Mobile Intel® Celeron® Processor on .13 Micron Process in Micro-FCPGA Package

Specification Update

Revision 020

Figure 12. System Bus Reset and Configuration Timings

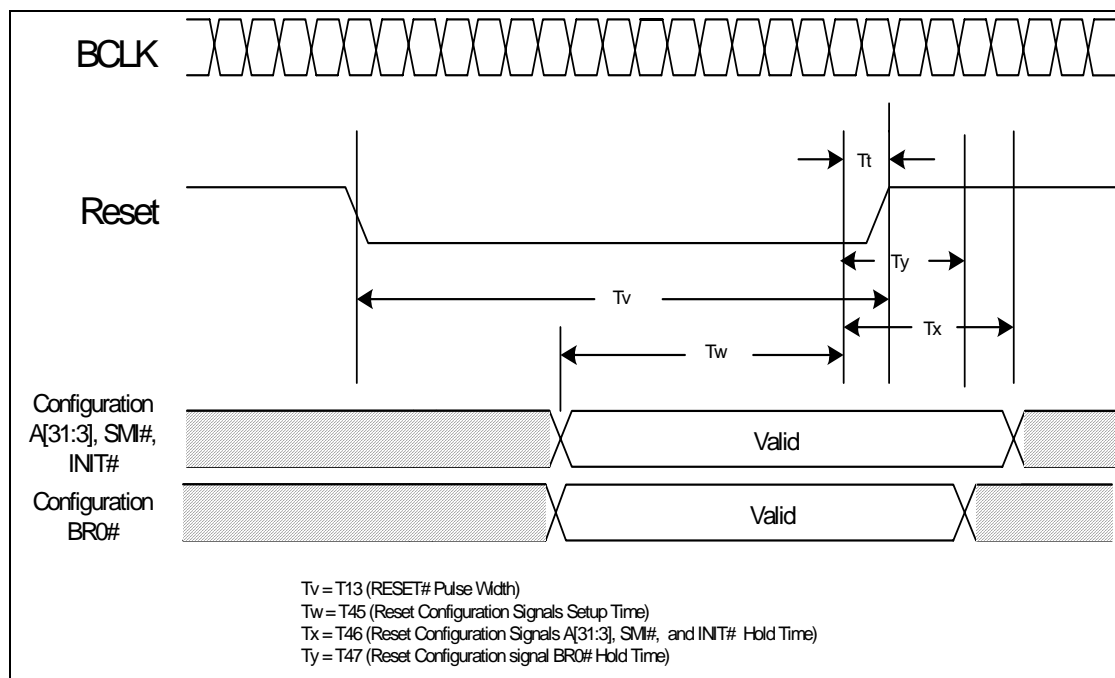
V2. BR0# Maximum Hold Time Specification Change

The BR0# maximum hold time has changed to 2 BCLKs. This change will be shown in the “System Bus AC Specifications (Reset Conditions)” table and “System Bus Reset and Configuration Timings” figure of the *Mobile Intel® Celeron® Processor on .13 Micron Process in Micro-FCPGA Package Datasheet*. This change will be incorporated in the next revision of the datasheet.

The following figure will be modified to reflect this change:

T# Parameter	Min	Max	Unit	Figure	Notes
T45: Reset Configuration Signals (A[31:3]#, BR0# INIT#, SMI#) Setup Time	4		BCLKs	13	1
T46: Reset Configuration Signals (A[31:3]#, INIT#, SMI#) Hold Time	2	20	BCLKs	13	2
T47: Reset Configuration Signal BR0# Hold Time	2	2	BCLKs	13	2

1. Before the deassertion of RESET#.
2. After clock that deasserts RESET#.
